TSTF-12-14  
PROJ0753

**SUBJECT:** Response to NRC Request for Supplemental Information and Withdrawal Regarding TSTF-534, Revision 0, "Clarify Application of Pressure Boundary Leakage Definition"

**Response to NRC Request for Supplemental Information Regarding TSTF-534, Revision 0,  
"Clarify Application of Pressure Boundary Leakage Definition"**

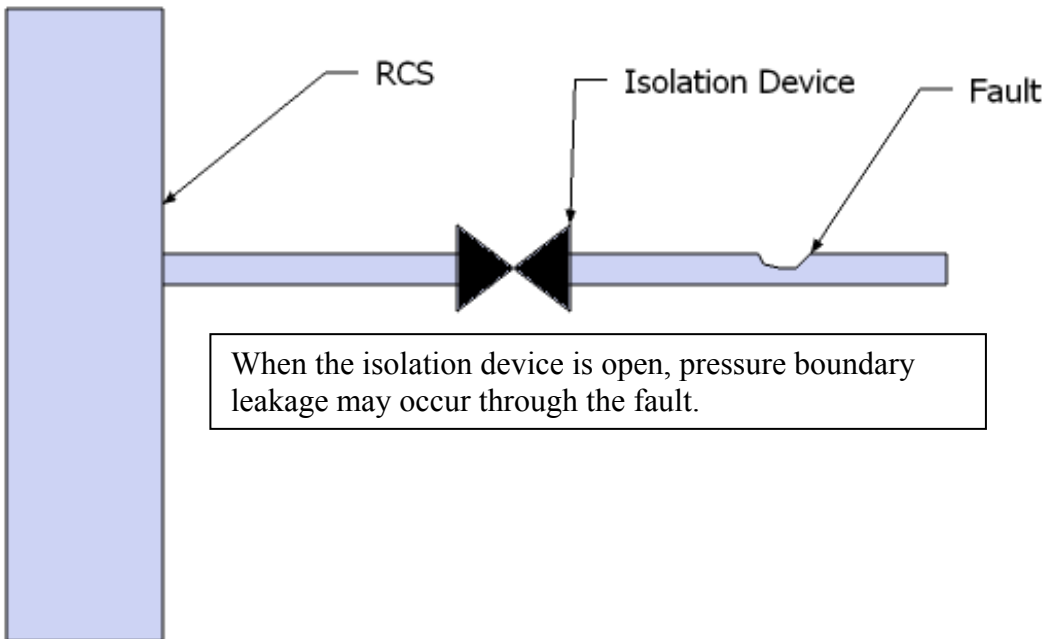
It is important to note the distinction between pressure boundary leakage (i.e., leakage through a fault in a RCS component body, pipe wall, or vessel wall) and the proposed limit on isolation device bypass leakage. The following diagram illustrates this distinction.
